0	0.5	1	1.5	2	2.5	3.5	5		
PROJECT RYLANDS BUILDING, MANCHESTER							SCALE 1:50@A0	DATE DEC 2023	
TITLE C29 PROPERTIES (MANCHESTER) LTD							JOB NO. 15626	DWG NO. AL(28)120	REV A
TITLE PROPOSED TYPICAL SOFFIT SCENARIO LEVEL 07 CUPOLAS							ISSUE FOR CONTRACT DOCUMENT

WEST CUPOLA PLAN

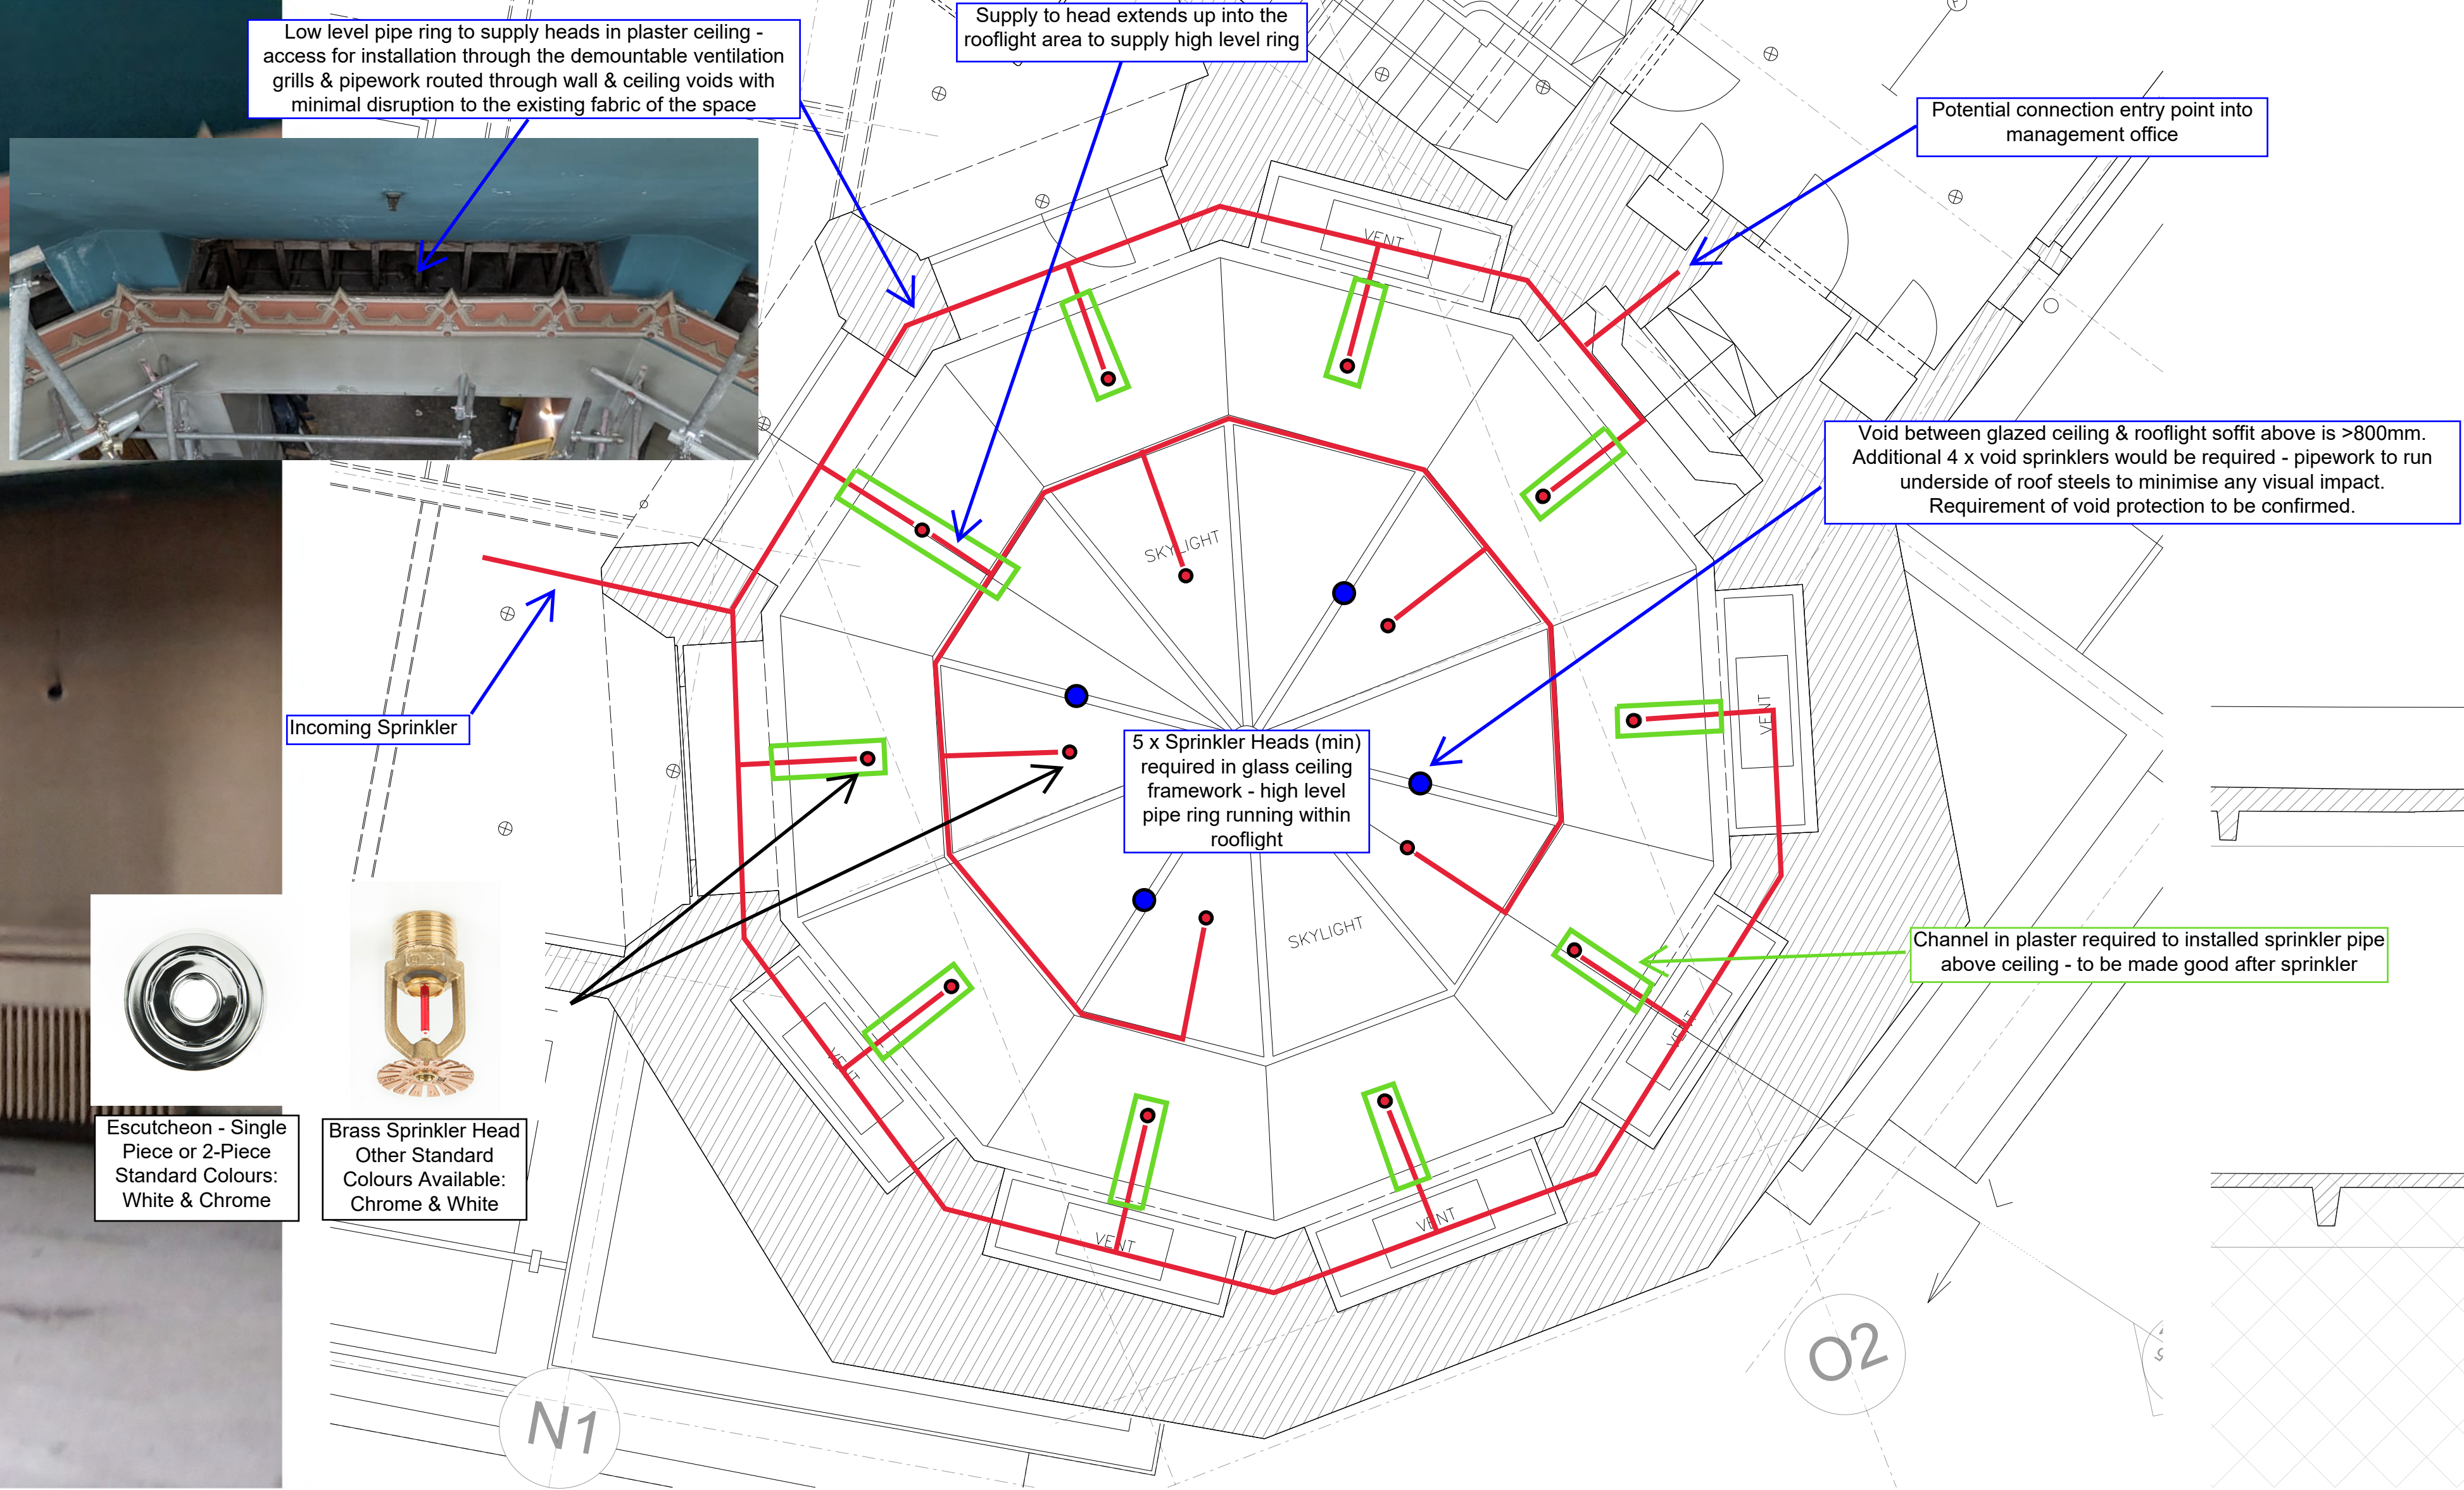
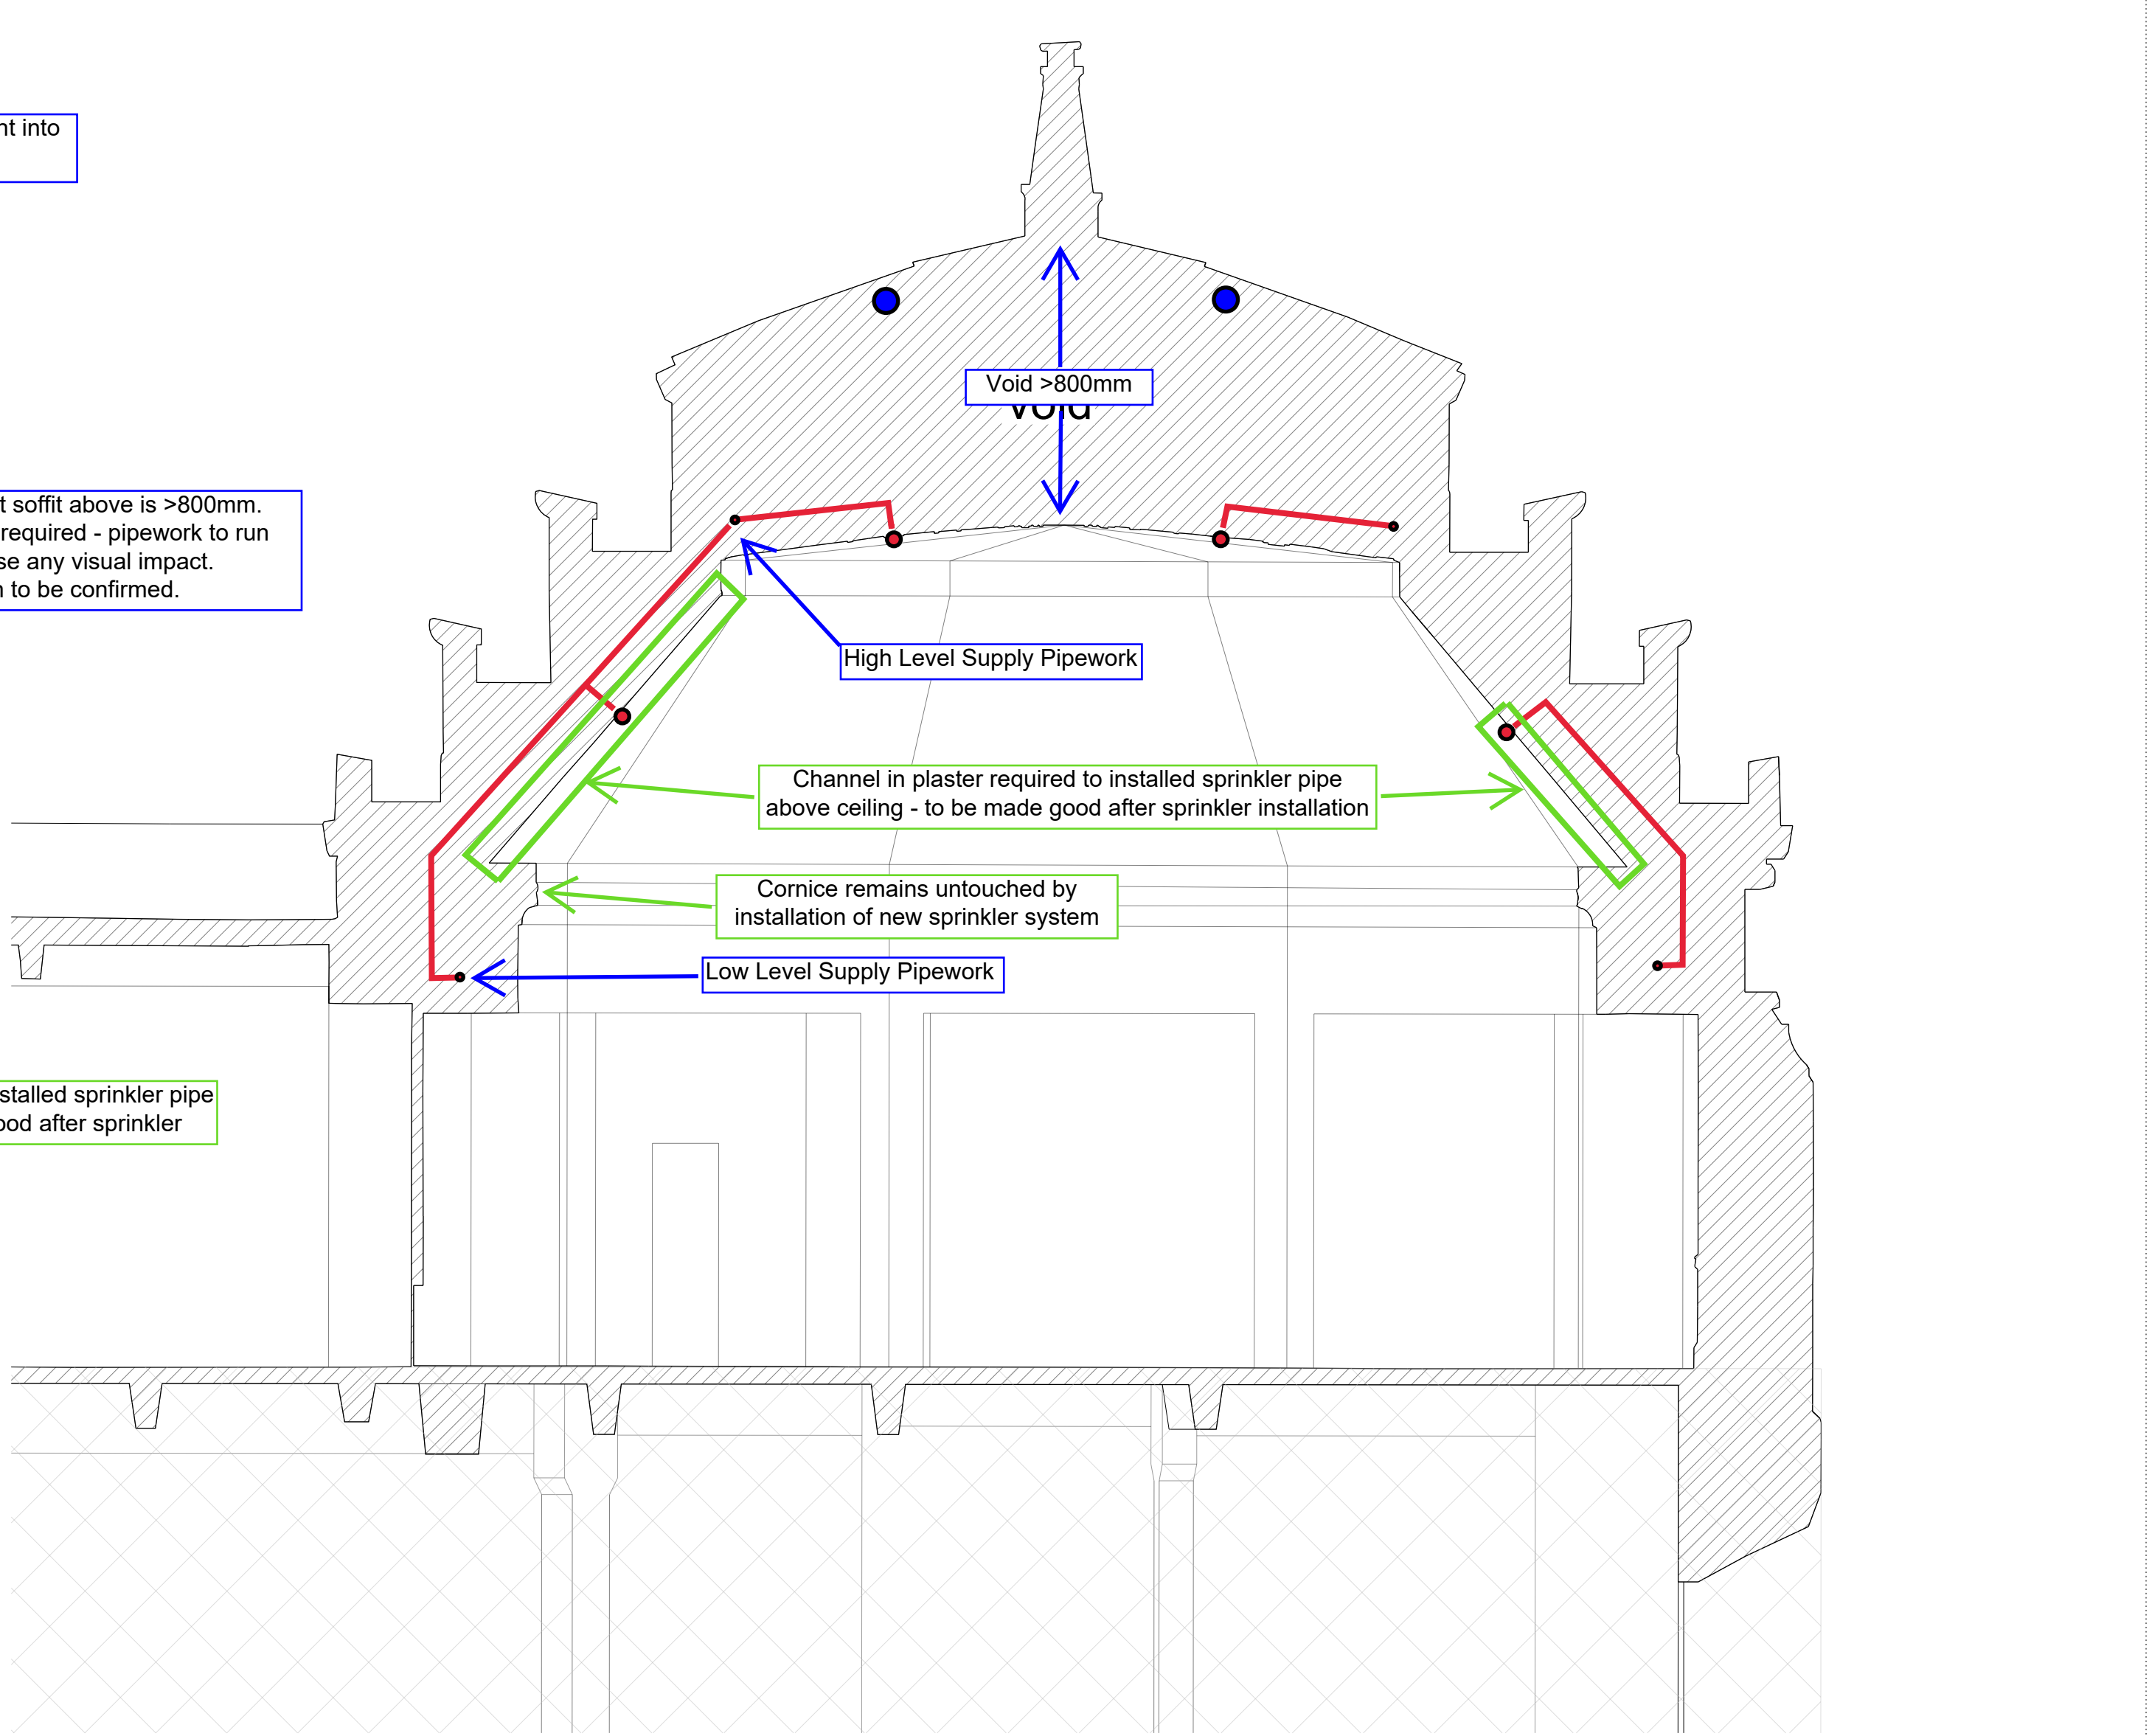
Cupola Sprinklers Option 1:
Replace old sprinkler system like-for-like with new sprinkler heads & pipework. Pipework to be concealed behind walls & ceiling as per the original sprinkler system and sprinkler heads located within the frame of the glass ceiling as per the original system.

GENERAL - Updates required to accord with updated Demolition & Encasement Removals AL(03)Series, and General Arrangement AL(04)Series.
